# Smarter journeys, together. Wakatipu Active Travel

COMMUNITY ENGAGEMENT SUMMARY  
MARCH 2021

# Progressing improvements to Wakatipu Trails

## A2 SHOTOVER RIVER / KIMIĀKAU BRIDGE TO FRANKTON

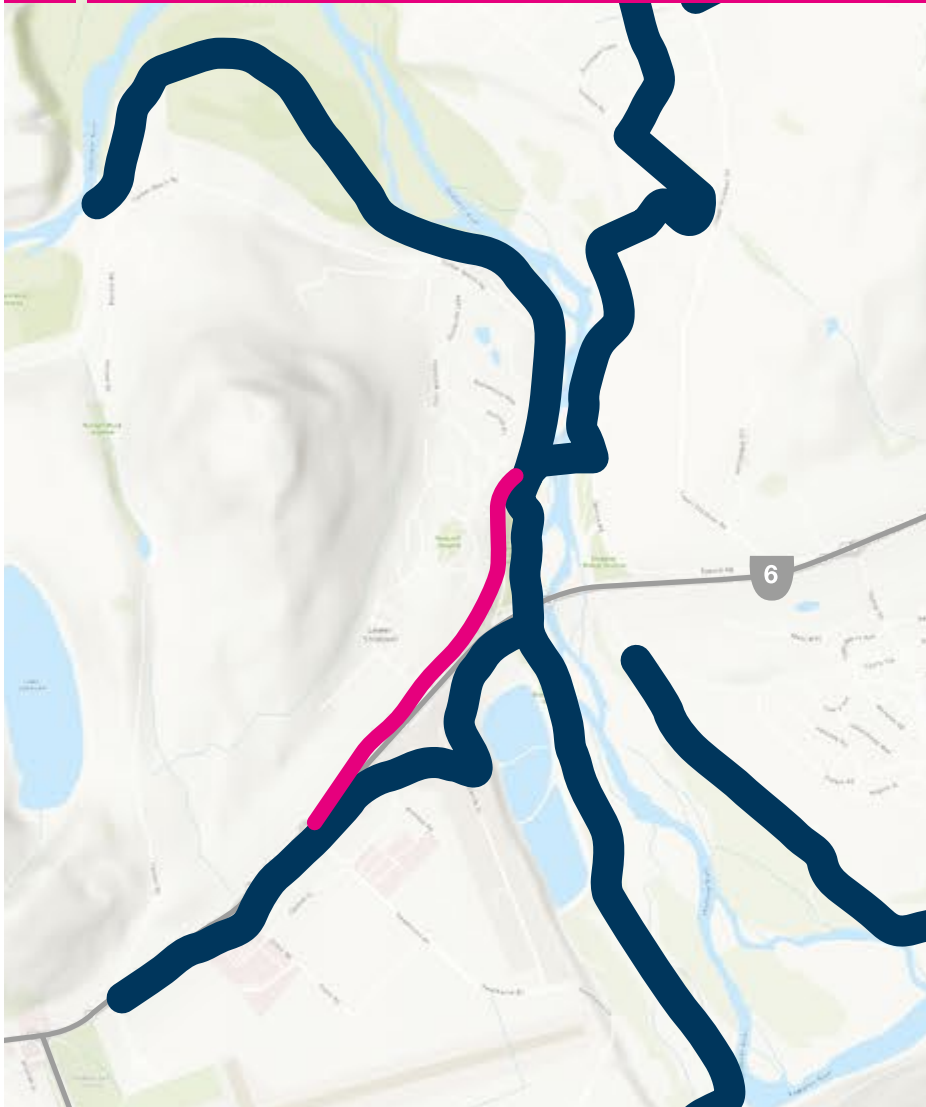
Several respondents highlighted a need for improved safety for users crossing SH6.\*

Suggestion to slow traffic on Tucker Beach Road east and west of Ferry Hill Drive.

Concerns were raised about personal safety near the quarry.

Suggestion to include another bridge further down the Shotover River.

Further links should be provided within Frankton to connect to Wakatipu High School and QLDC Events Centre.

There were concerns about stormwater issues at the entrance to the bridge.

Suggestion to celebrate the heart of the trail network at the bridge.

An underpass is proposed in the future to enable path users to cross SH6 away from traffic.

Traffic calming is being proposed as part of the detailed design.

The new route will avoid the quarry area as it passes through Quail Rise instead.

A crossing further down the Shotover River was considered during the business case phase of the project. This was not taken forward as an option due to flood risks, length of bridge span and significant costs.

A future underpass between the A2 route and the Hawthorne Drive shared path will provide a safer off-road connection for cyclists to the high school. The underpass will also connect with the existing Queenstown trail to provide direct access to the QLDC Events Centre.

Stormwater drainage will be investigated across the route from the western end of the historic Shotover Bridge to Frankton.

Bike stands and wayfinding signage are proposed in this area to create a rest stop or meeting place for pathway users.

## JOE O'CONNELL DRIVE TO FRANKTON BEACHFRONT

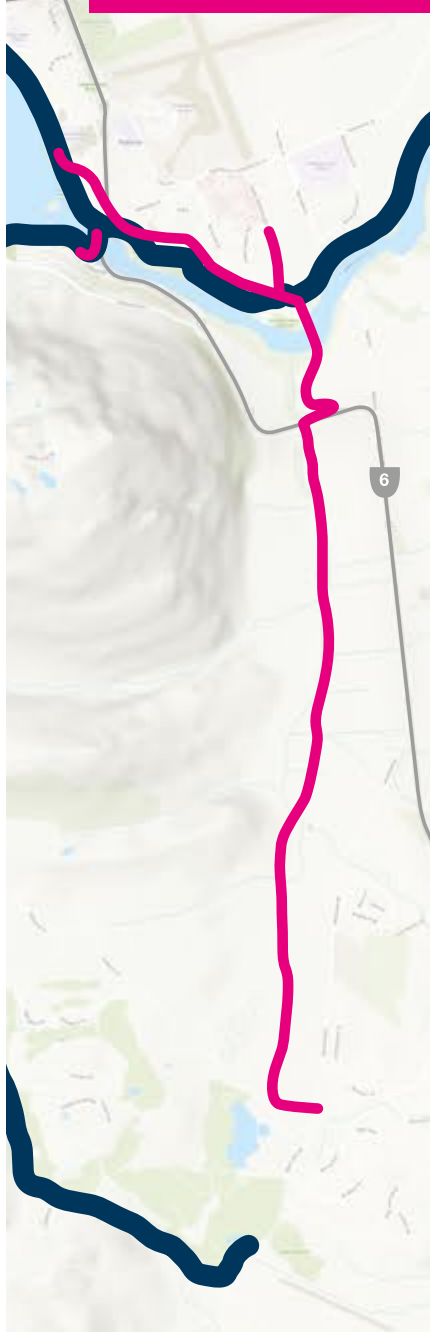
There should be a more direct route from Five Mile and Joe O'Connell Drive to the Frankton Beach/ Marina/ Frankton Bus Hub.

There should be a direct connection between SH6 and the lakefront for cyclists.

Queries regarding surfacing of the trails.

Concerns raised that the speed of cyclists may cause conflict with walkers/runners.

More bike parks at various points in the Five Mile Shopping Centre.

A temporary pathway is proposed adjacent to SH6 which connects directly from Joe O'Connell Drive to the roundabout. The route then connects via the existing crossing to Gray Street or the signalised pedestrian crossing adjacent to the Frankton Bus hub. The future BP roundabout project will address a more permanent solution to provide a more direct connection to the Marina as well. This project also includes a new pedestrian accessway adjacent to the Frankton camping ground.

Two routes between Yewlett Crescent and the Lakefront have been proposed to provide new safer and more attractive routes for pedestrians and cyclists. Pedestrians are provided a new footpath along Stewart Street and a new accessway via the camping ground (including stairs). The alternate route for cyclists is along Yewlett Crescent, Lake Avenue and Frankton Beach Access. This route has been chosen for its reduced gradient.

Generally, the pathways will be sealed. For unsealed sections, surfacing will enhance the experience for all users.

Consideration will be made for the various pathway users to enhance safety for everyone.

Although toilets and other amenities do not form part of this project the potential need and opportunity for such will be raised with QLDC.

## JACKS POINT TO FRANKTON TRACK

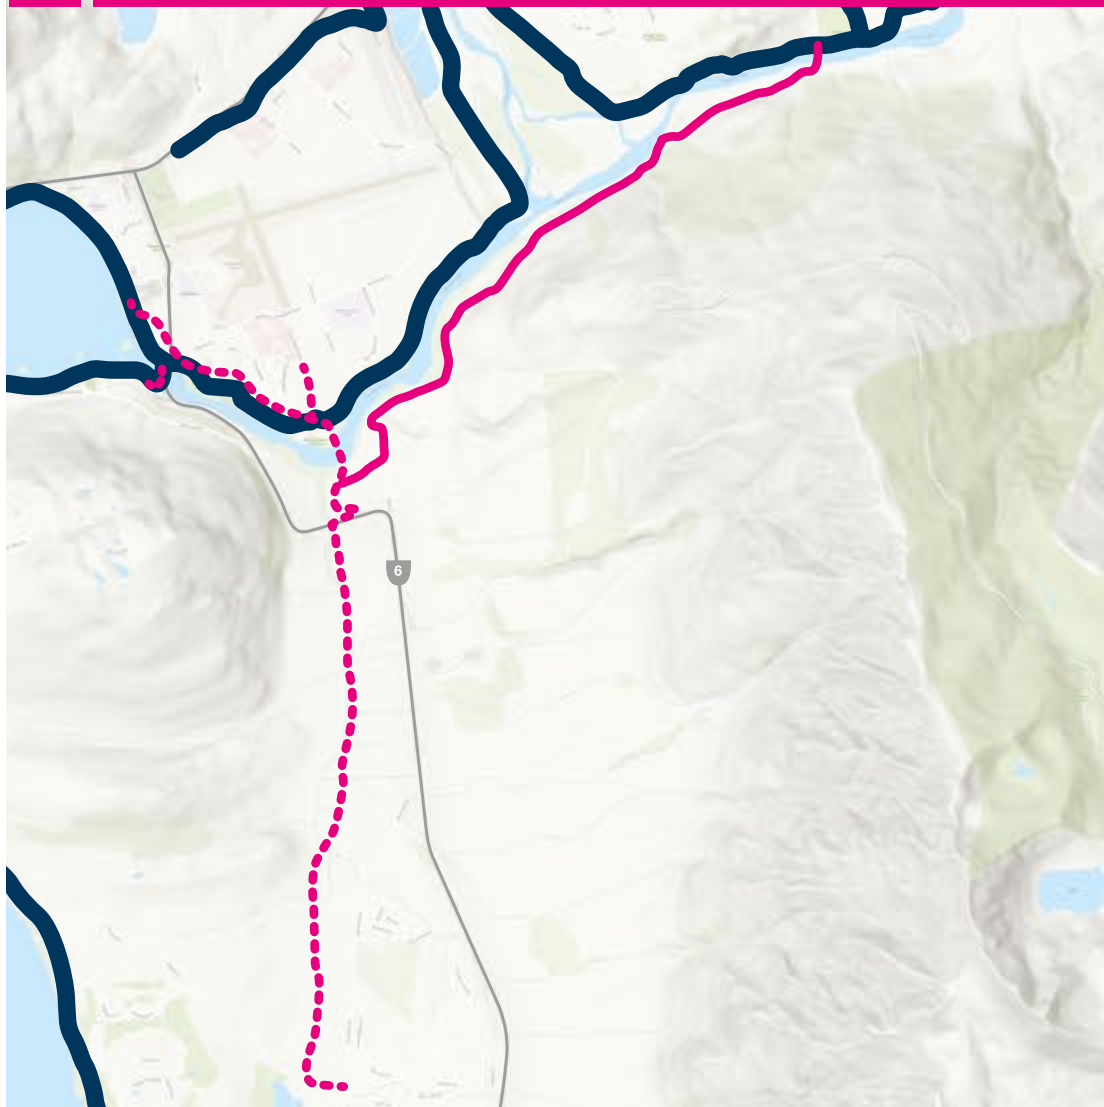
The trail from Hanley's Farm to the Frankton bridge is ideal, a sidewalk would be useful.

Suggestion for a connection from Hanley's Farm to the Jacks Point trail, which is the trail that links Jacks Point to Kelvin Heights via the lake edge.

Support for the new direct connection from Hanley's Farm and Jacks Point to Frankton. These submissions also highlight the need for a prioritized corridor for cyclists to address safety issues associated with riding along SH6.

Several submissions suggest lighting is not necessary along this route due the likely recreational nature of the trail and would have negative impacts including light pollution and impacts on wildlife.

Requests for a sealed path to enable a wider range of transport modes to use the trail comfortably including e-scooters.

The steep hill at the Kawarau Bridge needs to be dealt with. It is impossible to bike up the hill and definitely not possible with a bike trailer that holds a child.

Support for the bridge over Kawarau west of Boyd Road with a request for further detail of the location.

Suggestion for this route to be a dedicated path through the subdivisions - ideally to the west of the subdivisions along the base on Peninsula Hill. A path that provides a direct link between Frankton and Jacks/Hanleys (can be in metalled formation) – but provides regular links into the streets of the subdivisions.

Footpaths along the road are being developed as part of the Hanley's Farm subdivision. A walking and cycling trail that provides a connection between Hanley's Farm and Frankton is being provided as part of this route.

This is beyond the current scope of works.

An underpass is proposed to remove the safety issues of crossing the SH6 and the bridge will connect pedestrians and cyclists directly to Frankton.

Lighting is being considered across all trails. The application of lighting may need to vary across the trails, as usage and Crime Prevention through Environmental Design considerations will be variable.

The pathway is proposed to be sealed.

The trail in this location will stay at a high level to bypass this steep climb. The trail then crosses SH6 via a new signalised crossing at Humphrey Street.

Location is still to be determined. Design investigations and landowner coordination are ongoing.

Noted. The new route will largely be a dedicated path along the utilities corridor easement and through upcoming planned subdivisions, except where the developments have already been approved.

## A8 LAKE HAYES ESTATE TO FRANKTON

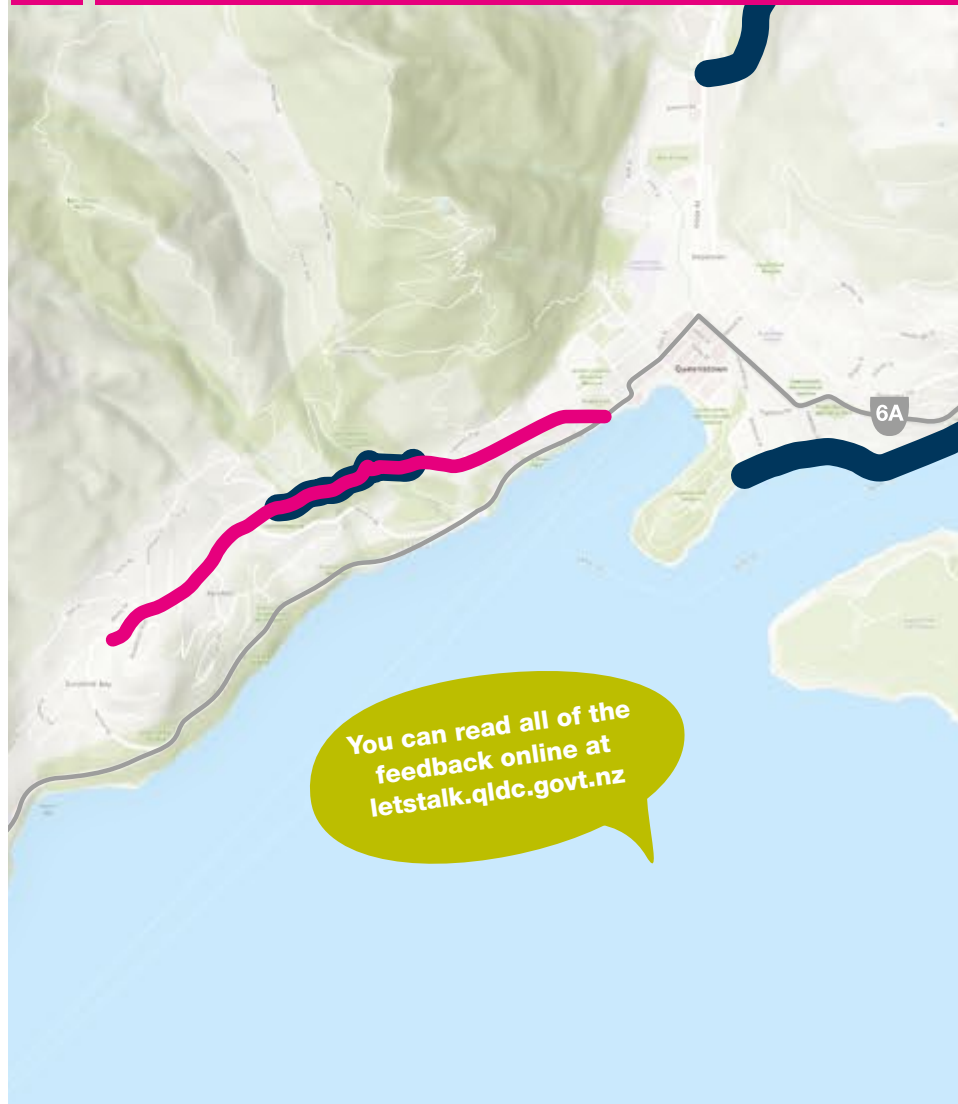
A quicker, more direct commuter route is wanted.

Safer crossing point(s) over SH6 are wanted.

Support for lighting along the route.

Consideration has been made for route options through this area at the business case phase.

This route does not go near SH6 and therefore this would need to be considered as part of other improvements.

Lighting is being considered across all trails. The application of lighting may need to vary across the trails, as usage and Crime Prevention through Environmental Design considerations will be variable.

## B2 FERNHILL TO QUEENSTOWN

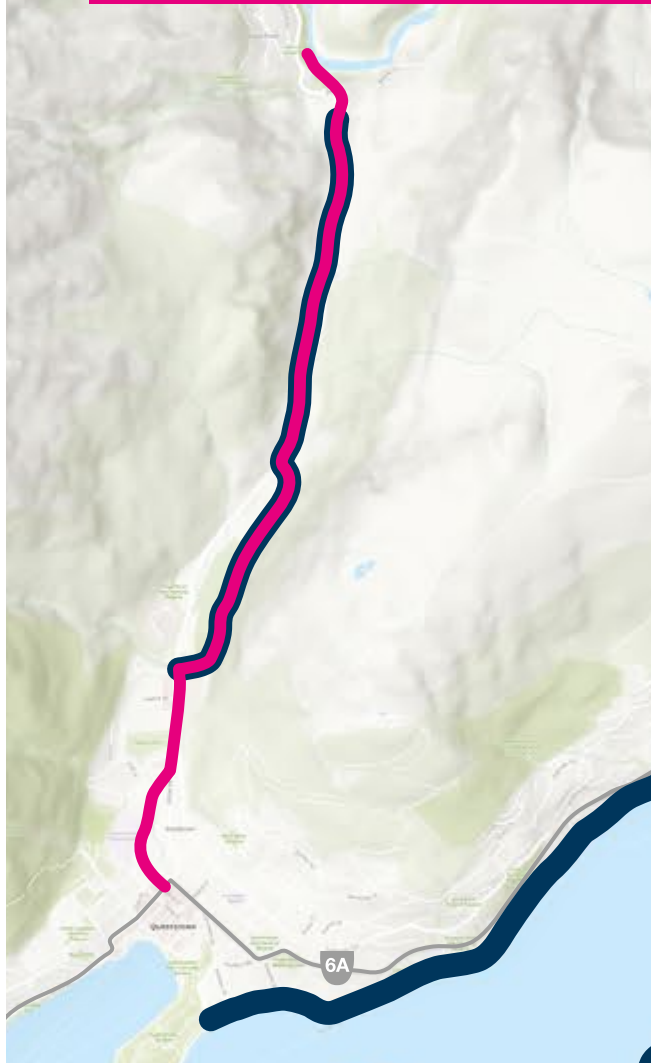
None of the respondents who live in the area want parking removed from Cameron Place.

Parking doesn't need to be removed from Fernhill Road between Lordens Place and Mackinnon Terrace, this is not heavily used by cycle commuter traffic.

Lighting in One Mile Reserve is supported.

There is already a suitable access onto the existing cycle route via the Fernhill Reserve car park and playground area that should be utilised rather than sending cyclists down Cameron Place.

We will look at a shared space alternative which will keep the existing carparking on Cameron Place.

We will reduce the length of the footpath widening for Fernhill which will retain some car parking. The footpath widening will now be between Watts Road and Greenstone Place.

We will investigate this as an option.

This is outside the scope of this project as the route was confirmed during the business case phase of the project.

## ARTHURS POINT TO QUEENSTOWN IMPROVEMENTS

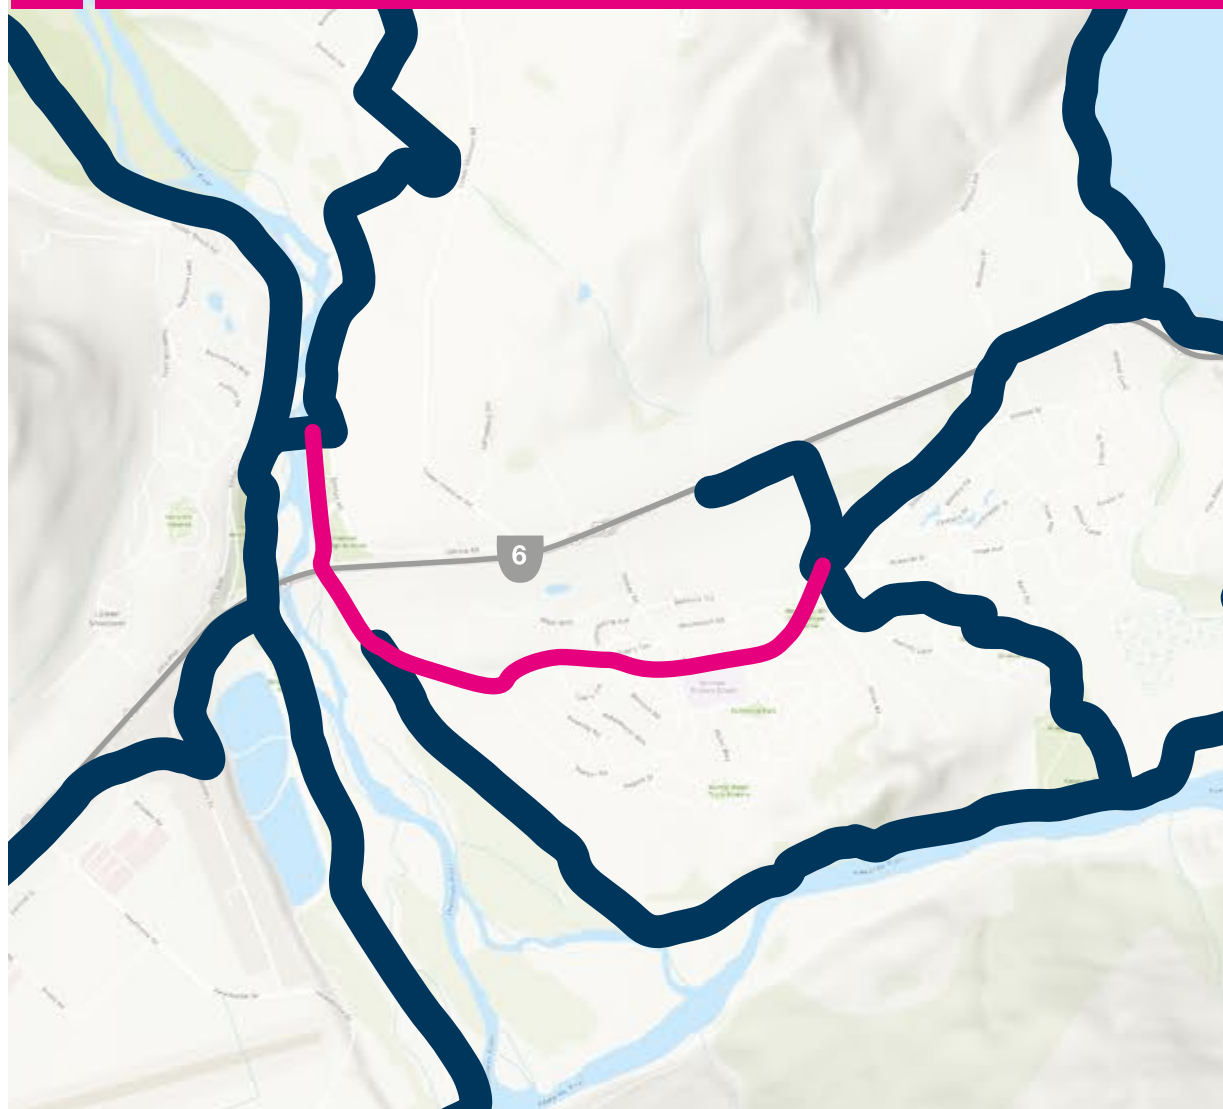
The improvements must be done at the same time as Arthurs Point Crossing.

Respondents preferred a direct on-road option to bypass Matakauri Park.

There was greater support for leaving the trail around Matakauri Park unsealed, but this would likely limit the use of the trail as a commuter route. Track surface would need to be sealed (asphalt not chip seal) to encourage uptake as a commuter route and to allow for different users (e-scooters/skateboards).

Most respondents were supportive of removal of car parking, but with some concerns raised regarding parking already being an issue for people in and near to town and the commercial premises.

There were safety concerns raised about crossing Gorge Road at Matakauri Park – needs to take account of longer bikes (e.g. cargo bikes) and greater volume of bikes.

We will look to coordinate with this project, which is in the final approval stages.

We are looking at shoulder widening on Gorge Road through this area to provide more road width for on-road cyclists.

We are not sealing around Matakauri Park Wetland. We are still assessing safe surfacing options for the rest of the route, this may be a combination of asphalt and chipseal.

We are investigating if parking on the opposite side of the road could be time limited so it can be used by businesses in the area.

We are currently investigating a signalised crossing that is user activated to allow people to cross safely. If the crossing point isn't signalised we will attempt to maximise any pedestrian refuge space as much as possible.
